MONTGOMERY COUNTY HISTORIC PRESERVATION COMMISSION
STAFF REPORT

| Address: | 2240 Brighton Dam Road, Brookeville | Meeting Date: | 5/14/2025 |
| Resource: | <i>Master Plan Site #23/82</i> (Grafton Holland Farm) | Report Date: | 5/7/2025 |
| PROPOSAL: Partial grading and tenant house construction | | | |

Figure 4: Diagram showing the relationship between clapboards and rubblestone foundation (BuildingSciences.com)

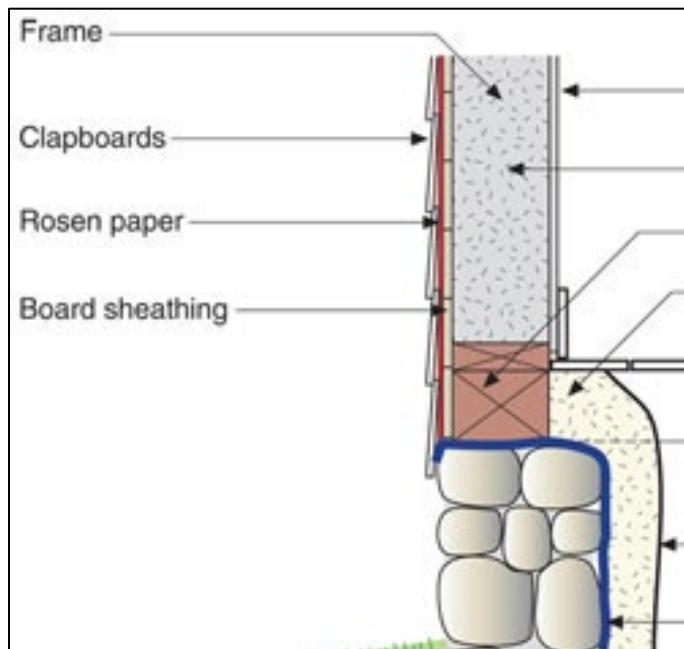
Staff finds that the applicant has largely satisfied the condition of HAWP #958637 in this proposal. However, Staff requires additional information about the relationship between the historic stone foundation and the new construction. Historically, the exterior walls and siding would be aligned with the outer edge of the stone foundation, and the clapboard siding would slightly overlap (*Figure 4*). The applicant must submit a section drawing showing this detail and include Montgomery County Planning Staff in preconstruction meetings with DPS.

6. A section detail showing the relationship between the existing foundation and the new exterior wall and siding must be submitted to staff for final review and approval prior to issuance of HAWP. The applicant must include Montgomery County Planning Staff in the initial preconstruction meeting with the Department of Permitting Services (DPS).

Figure 5: North (front) elevation of the proposed tenant house.

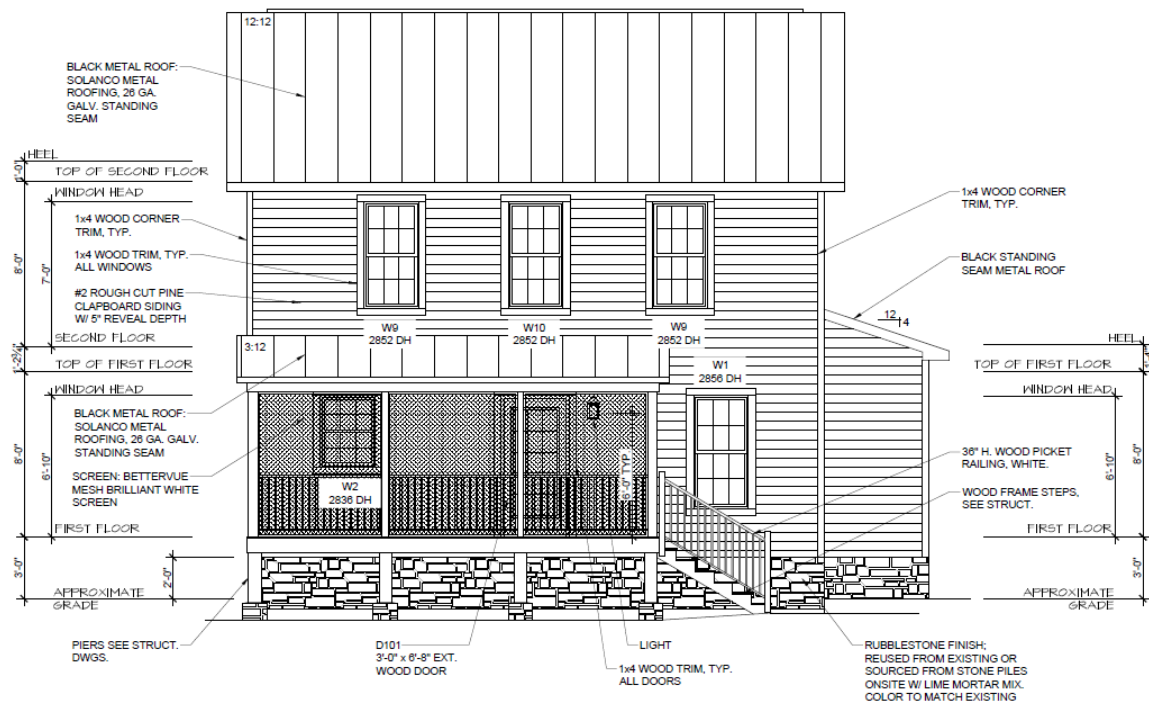
The construction of the new tenant house is subject to review under 24A(b) and *Standards 2, 9, and 10*. Although the design for the proposed house has been modeled after a historic construction, Montgomery County Code does not adhere to any specific preservation standards for reconstruction. Therefore, review of this proposal centers on evaluating the new construction for compatibility with the historic site and not on its fidelity to the design of the pre-1961 tenant house.

Staff finds although the applicant is not bound to mimic the historic design, replicating the overall size, scale, proportions, and massing of the historic tenant house is a good strategy to ensure compatibility with the historic resource and site under *Standard 9*. The proposed materials, which include wood double hung windows, wood clapboard siding with a 5 (five) inch reveal, and a standing seam metal roof, are compatible with the character of the property, also in accordance with *Standard 9*. This new construction, if removed in the future, will not impact the essential form and integrity of the property, as the only remaining historic material is the stone foundation, in accordance with *Standard 10*. The proposed house has no significant impact on the environment of the property.
